Technical Bulletin

Number 111
June, 1979

SPRING REPLACEMENT KIT FOR LOAD PUSH/PULL

For Models: P5B, P5S, P7B, and P7S

Figure 1 - Original Spring

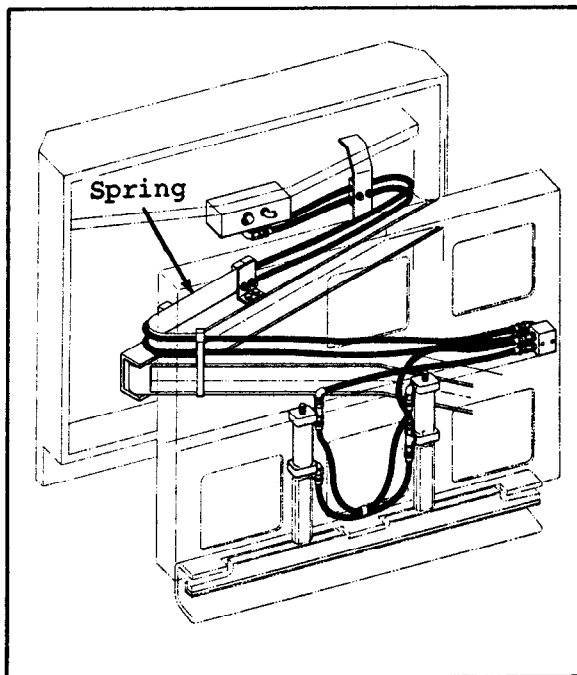
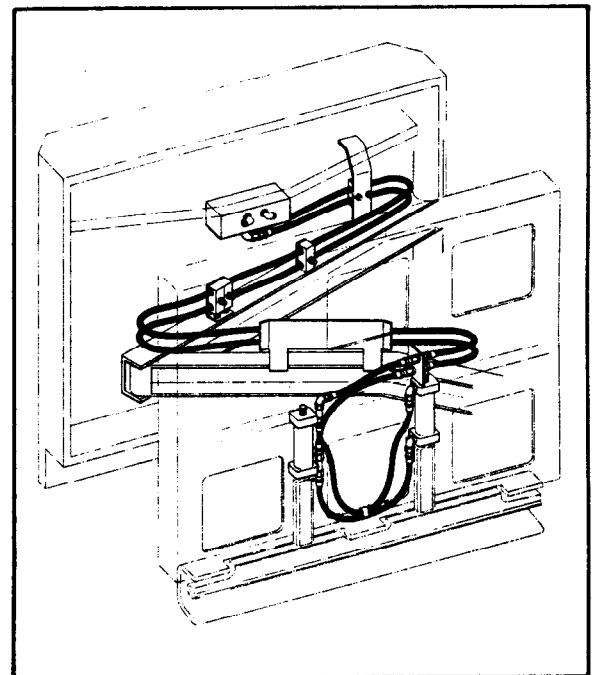
A spring replacement service kit is now available for Cascade Load Push/Pull models P5 and P7 that have been experiencing short service life of the spring shown in Figure 1 below. The kit provides all the necessary hardware and instructions to make the change. The complete installation of the kit will take approximately 2-1/2 hours.

Required tools for installation are a Drill (.257" Diameter), a Tap (.3125-18 UNC), and a cutting torch.
